SUBJECT: LA-6 Model

DATE: March 1 , 1934

This Bulletin supplies detailed supplementary information to that issued in Machine Service Bulletins No. 161, Supplements A, B, C and D, and 165, 167 and 177.

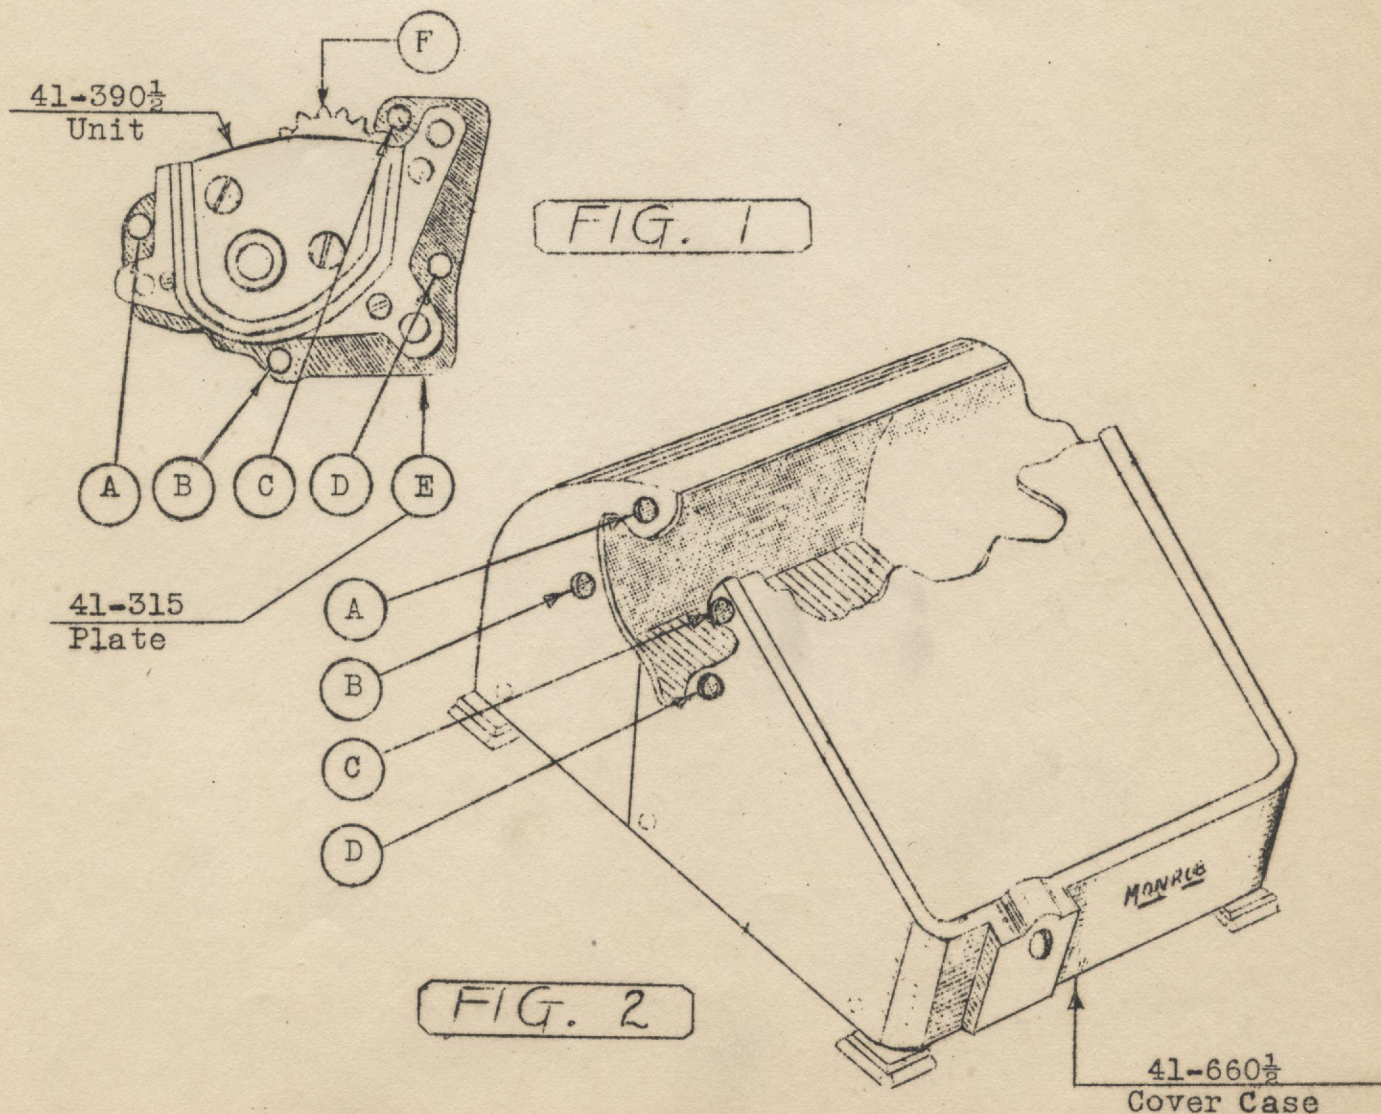
The fastening of the machine cover case, 41-660 $\frac{1}{2}$ , to the through carry unit, 41-390 $\frac{1}{2}$ , with screws 50506 through holes (A), (B), (C) and (D) may disturb the correct alignment of the extreme left hand extra carry gear (F) with the intermediate gears. This is due to the strain set up by the tightening of these screws. Machines in perfect operating condition often function improperly on account of this. Therefore, the use of shim washers between the end plate (E) and the cover case was resorted to. However, a change has been made in the cover case which eliminates holes (A), (B), (C) and (D) and omits the use of screws 50506.

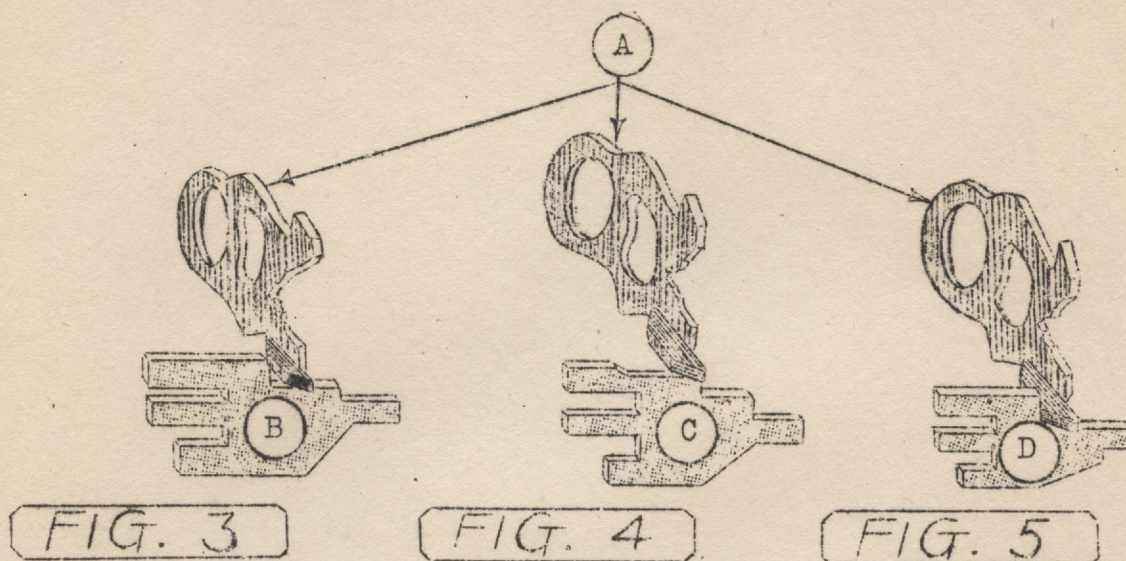
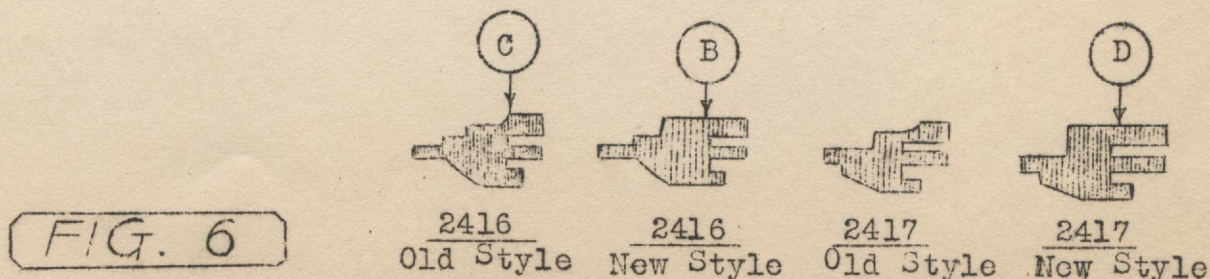
An improvement has been made in the carrying dogs by adding a small amount of stock on the top of the dogs at the points where they contact the feet of the wedges. See (B) and (D), Figure 6. In LA-6 models, due to the use of round tooth gears in the extra carry unit, it is necessary to set a slightly higher mesh between the dial gears and intermediate gears than in other L models. This higher mesh causes the wedges (A) to be depressed slightly later by the carrying pins than with the deep mesh, and we have found that this delay, even though it is slight, causes the wedges, when they are depressed, to strike the top of the dogs rather than to drop in front of them. In order to overcome this condition, we have added a small amount of metal to the top of the dogs so that the delay in depressing the wedge is compensated.

Figure 3 illustrates the correct engagement of wedges (A) with the new style 2416 dogs (B).

Figure 4 shows the incorrect condition caused by the wedges (A) dropping late and riding on top of the 2416 old style dogs (C).

Figure 5 illustrates the correct engagement of the wedges (A) with the new style 2417 dogs (D).

FIG. 7

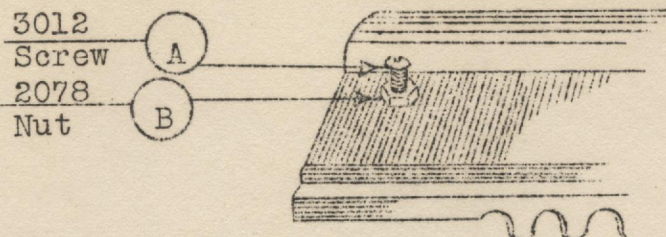
Set screw (A) has been provided to limit the movement of the trip rod (H) when the constant key is depressed.

If the correct number is not registered when setting the constant into the carriage and the machine is without this feature, install screw (A) and nut (B) by following the instructions listed below. NOTE: After installing screw (A) and nut (B), if the correct number does not register when setting the constant into the carriage, adjust screw (A) up or down until the trouble is corrected.

- 1 - Position the rocker arm assembly (D), as shown. Raise stud (C) with the fingers as far as possible. In doing so, lug (F) contacts the carriage case (E) and leaves a slight mark as indicated by (G).
- 2 - Center punch this mark.
- 3 - Drill a hole through the case with a #50 drill, using the center punch indent as a guide.
- 4 - From the outside of the case enlarge the hole with a #49 drill and tap it with a 2-64 tap.
- 5 - Install nut (B) on screw (A) and insert (A) in the case to suit and tighten (B) securely.

NOTE: To allow for free movement of rocker arm (D) after installing screw (A), it may be necessary to grind (D) at (F).

FIG. 20

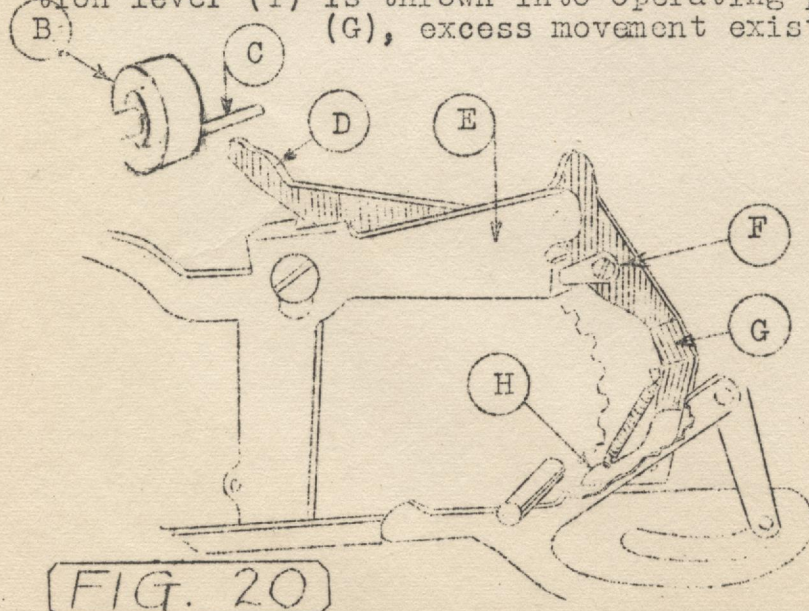
The eccentric screw stud (E) on Plate 9, should be adjusted so that roller (Q) does not contact the aperture in link (F) when slide (G) is unlatched from (P). Machines not equipped with a 49105 stopping blank shown as (M), should have this feature installed. After installing blank (M), neutralize the division and multiplication levers and adjust blank (M) to the end of link (F) so that .015 clearance exists at (U). After the proper adjustment has been made, tighten the tie rod screw (N) securely. To test this adjustment throw the division lever in and snap it out of the divide position. When it is restored to neutral, link (F) should not contact roller (Q) enough to cause any upward movement of (G).

Screw (R) should be adjusted in slot (S) so that when the multiplication lever (T) is thrown into operating position and roller (Q) raises (G), excess movement exists after (G) latches on (P).

FIG. 21

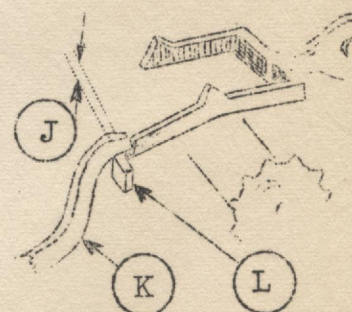
Adjust blank (F) so that when dial (B) is at zero and slide (E) is unlatched, (D) will clear pin (C) by approximately  $1/32$ ". When clearance exists at (J) and (E) is latched upward, turn dial (B) to zero and raise the carriage. See That the automatic left hand side mechanism is set to neutral.

FIG. 25

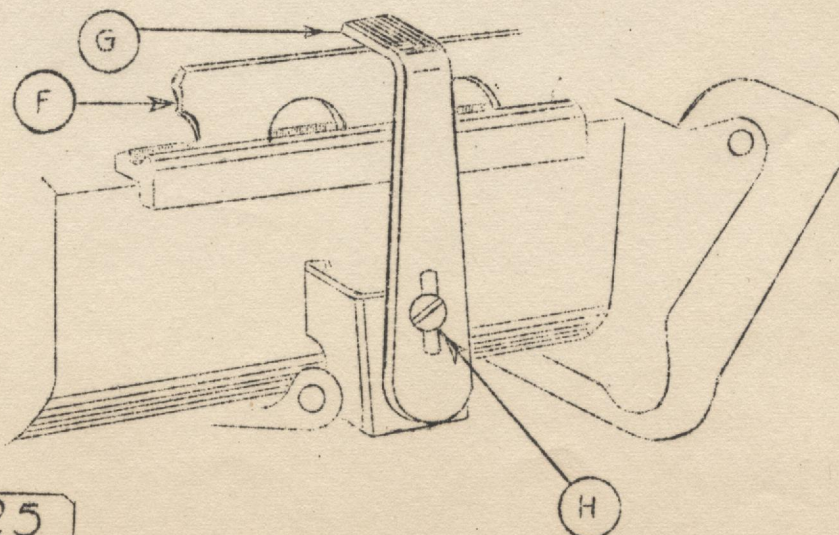
The unit carriage lock (G), if distorted, may not function properly in relation to the carriage lock ledge (F). This should be corrected by readjusting (G) to (F) and tightening screw (H) securely. It is advisable to check the lock for free movement without spring tension.

FIG. 26

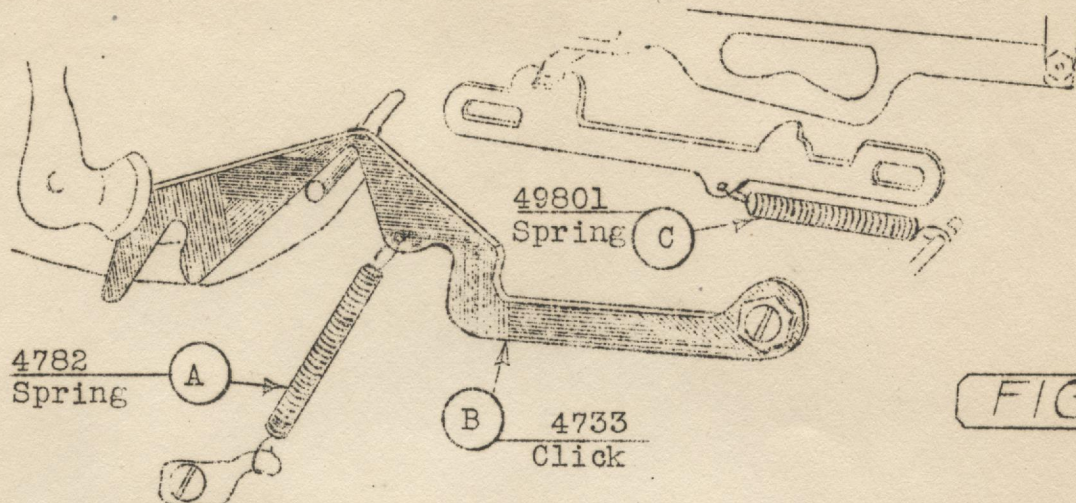
The new style division lever click (B) should be installed in all machines. (See Machine Service Bulletin No. 161-B, Plate 28.) Upon installing the new click it is important that spring (A), 4782, is of standard length and tension. Therefore, if the original spring has been shortened, replace it. It is also necessary to replace (C), 49801, with a 788 spring.

FIG. 28

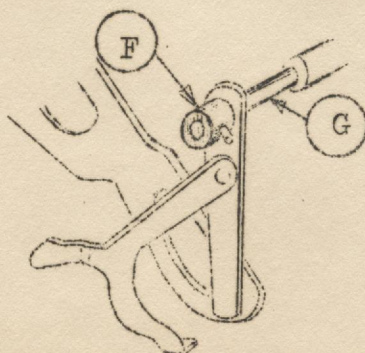
Ascertain that the right hand ends of hub (F) and shaft (G) do not interfere with the cover case, 41-660 $\frac{1}{2}$ . To remedy this condition grind the face of hub (F) and shaft (G).

FIG. 29

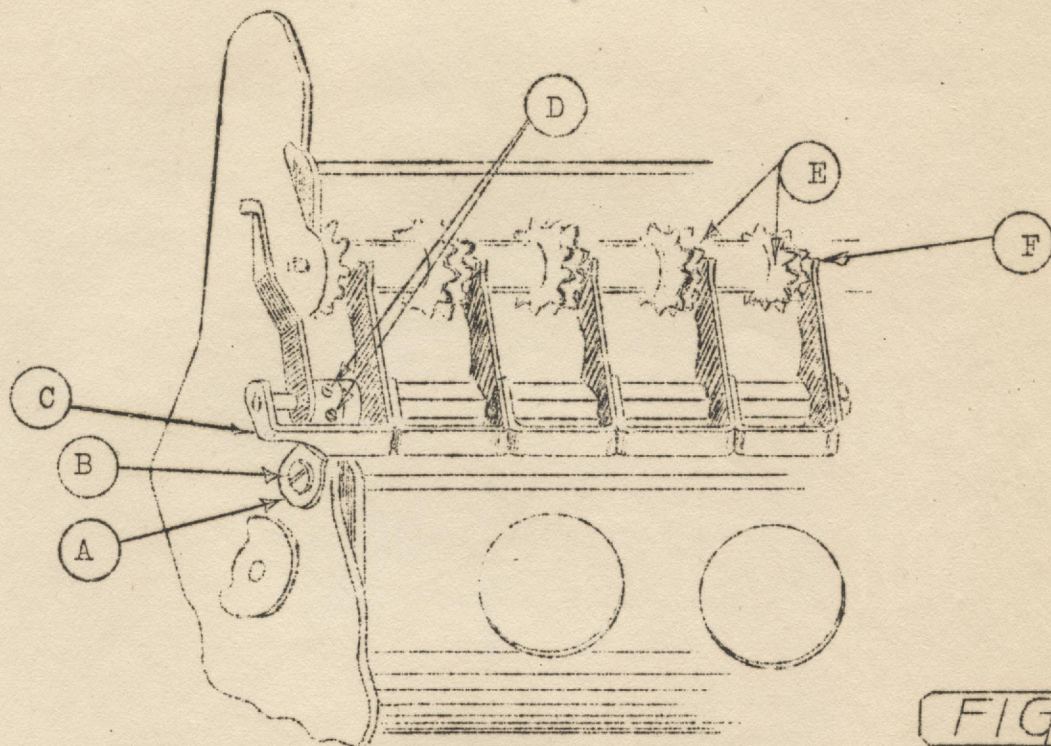
If at the end of subtraction in automatic division, or at the end of the forward correction cycle, the machine should continue to run, trip levers (F) are adjusted too low.

If in automatic division, the machine should reverse itself before the division is complete in a column, the trip levers (F) are adjusted too high.

The points of trip levers (F) should extend slightly below the surface of the teeth on gears (E). Holding the points at this position, loosen (B) and place blank (A) up against the fold of arm (C) and tighten screw (B) securely. Loosen screws (D) and position arms (F) upward or downward in relation to the regular trip lever. After the desired adjustment has been made tighten screws (D) securely.
